CONNECTICUT SITING COUNCIL

RE: **DOCKET NO. 508** – The United Illuminating Company (UI) Certificate of Environmental Compatibility and Public Need for the Milvon to West River Railroad Transmission Line 115-kV Rebuild Project that consists of the relocation and rebuild of its existing 115-kilovolt (kV) electric transmission lines from the railroad catenary structures to new steel monopole structures and related modifications to facilitate interconnection of the rebuilt 115-kV electric transmission lines at UI's existing Milvon, Woodmont, Allings Crossing, Elmwest and West River substations along approximately 9.5 miles of the Connecticut Department of Transportation's Metro-North Railroad corridor traversing the municipalities of Milford, Orange, West Haven and New Haven, Connecticut. **Partial Development and Management Plan I Revision.**

Re: Docket No. 508 - The United Illuminating Company Application for a Certificate of Environmental Compatibility and Public Need for the Milvon to West River Railroad Transmission Line 115-kV Rebuild Project - Request for Modification to Structure Locations Near West River Substation

XS-12 (FACING WEST RIVER SUBSTATION)

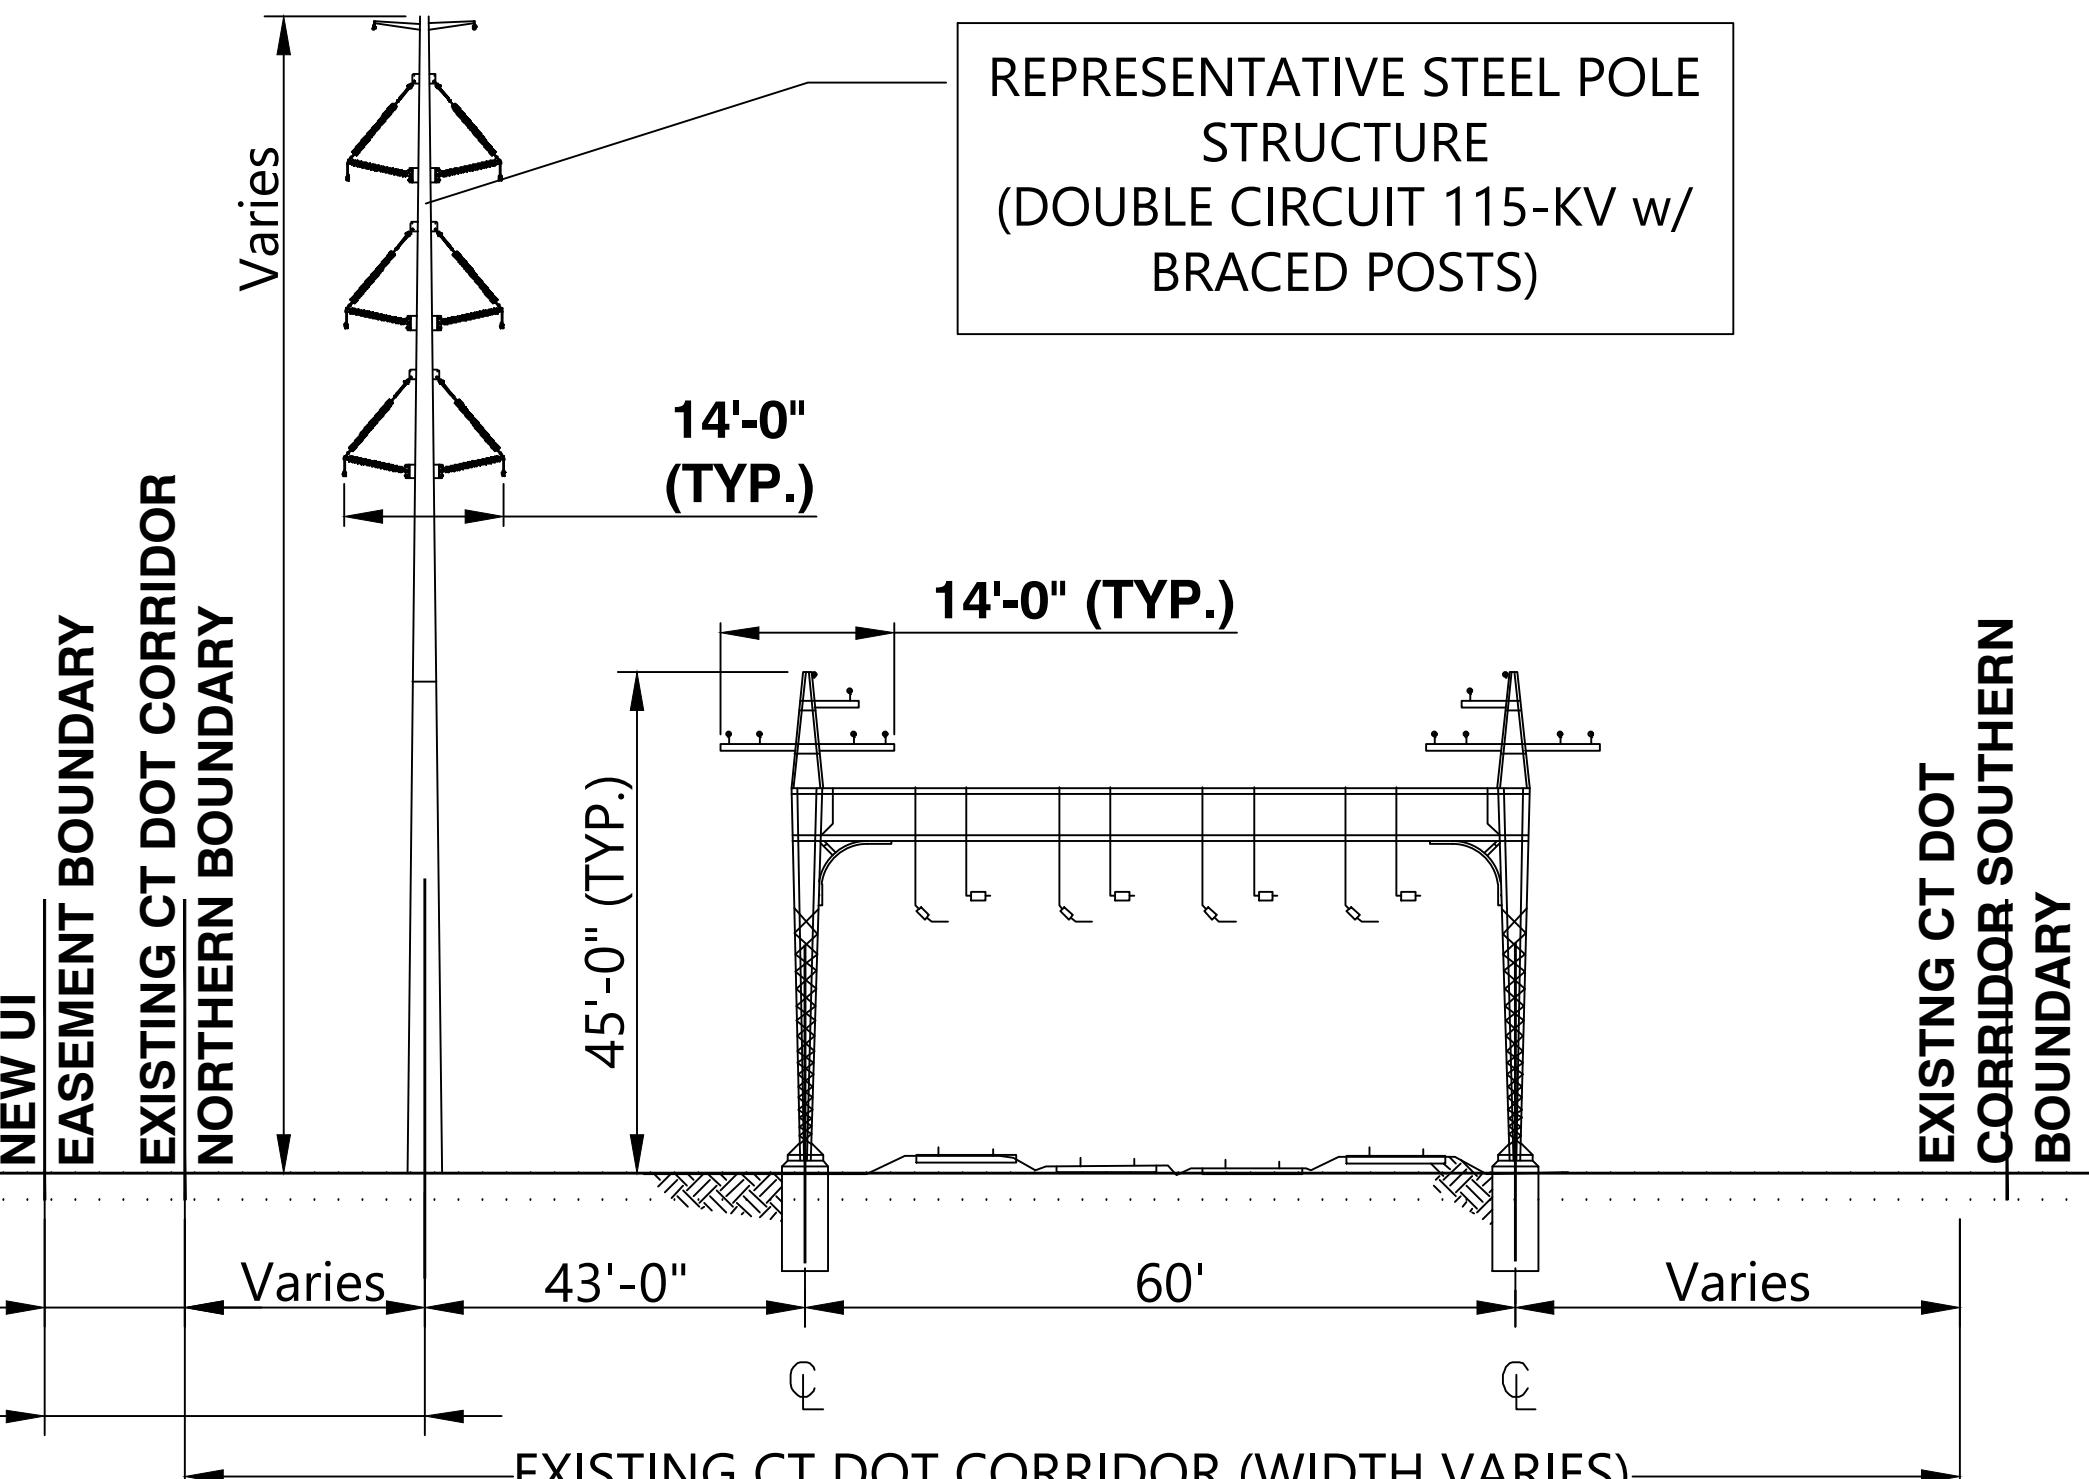
Structures P1035N and P1037N require an increase in height due to the increased span length and will be shifted farther north to accommodate future planned spur tracks and work areas for Metro-North Railroad and the Connecticut Department of Transportation.

- One of the double circuit steel monopoles originally planned for location along the north side of the MNR tracks in West Haven will be eliminated.
- Structures P1035N and P1037N will increase in height (to 120 and 125 feet, respectively) because of increased span length due to the elimination of P1036N and to maintain required vertical clearances for an adjacent building. These two structures were shifted farther north to accommodate the future planned spur tracks and work areas for MNR and CDOT.
- The realignment of P1035N and P1037N to the northern edge of the CDOT property will require easements on adjacent private properties, which will result in an additional 0.34 acre of permanent easements for the Project.

STRUCTURE NO.	STRUCTURE TYPE	CROSS SECTION	HEIGHT (FT)	FOUNDATION
P1037N	DEADEND	XS-12	121	CONCRETE DRILLED PIER
P1038N	TANGENT	XS-13	126	CONCRETE DRILLED PIER
P1039N	TANGENT	N/A*	131	CONCRETE DRILLED PIER
P1039EN	TANGENT	N/A*	131.5	CONCRETE DRILLED PIER
P1040N	TANGENT	N/A*	131	CONCRETE DRILLED PIER
